Department of Energy
Albuquerque Operations Office
P. O. Box 5400
Albuquerque, New Mexico 87115

Enclosed are responses and back-up information in response to NRC comments contained in your letter of May 17, 1985, dealing with the Shiprock Construction documents as well as your letter of June 6, 1985, dealing with the Shiprock Final Remedial Action Plan. Could you please provide your response regarding the acceptability of this information as soon as possible. We require a response prior to October 4, 1985 since the Shiprock Remedial Action is currently in progress.

RESPONSE TO NRC COMMENTS
OF MAY 17, 1985, ON
SHIPROCK CONSTRUCTION DOCUMENTS - SURFACE WATER HYDROLOGY

RESPONSE TO NRC GEOTECHNICAL COMMENTS
OF MAY 17, 1985 ON
SHIPROCK CONSTRUCTION DOCUMENTS (SPECIFICATIONS)

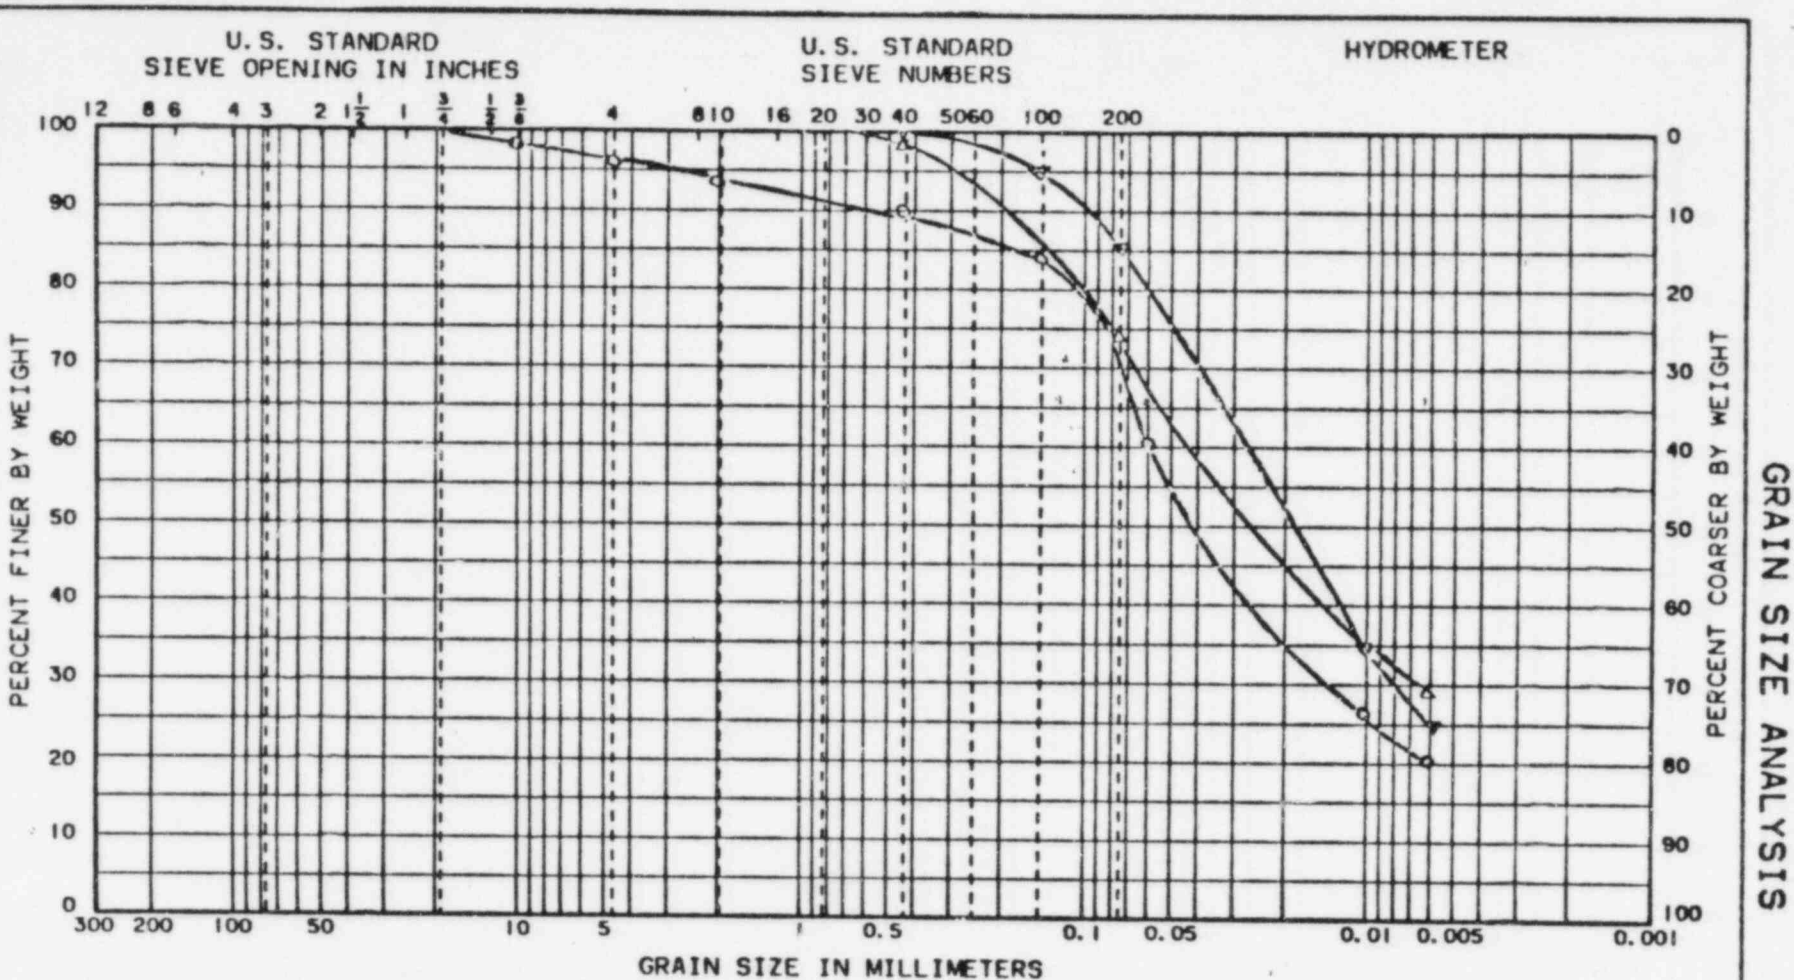
"Items 2.1.C.4A specifies the gradation for the Type B rock material cover proposed for the tailings embankment side slopes, drainage ditches, and intercept ditches. There is a 6-inch thick bedding material between this rockfill cover and the radon barrier earth cover over the tailings pile. The proposed gradation of the Type B rock material and the select bedding material do not comply with the filter criteria gradation requirement $D_{15}/D_{85} \leq 5$. This is a design requirement and the specification of all the materials proposed for covering the tailings embankment should comply with the filter gradation requirement."

Specification 02270, Item 2.1.C.4 gives gradation requirements for Type B rock material and Select Bedding Materials. The requirements do not meet the criteria D_{15}/D_{85} not to exceed five.

The purpose of this criteria is to prevent migration of fines from the bedding material into the overlying rock material. The primary force tending to cause this to happen is the rainfall which flows through the voids in the rockfill.

The attached calculation shows that the velocity of water flowing in the voids is less than the velocity required to cause erosion of the bedding material. Therefore, the gradations specified are satisfactory.
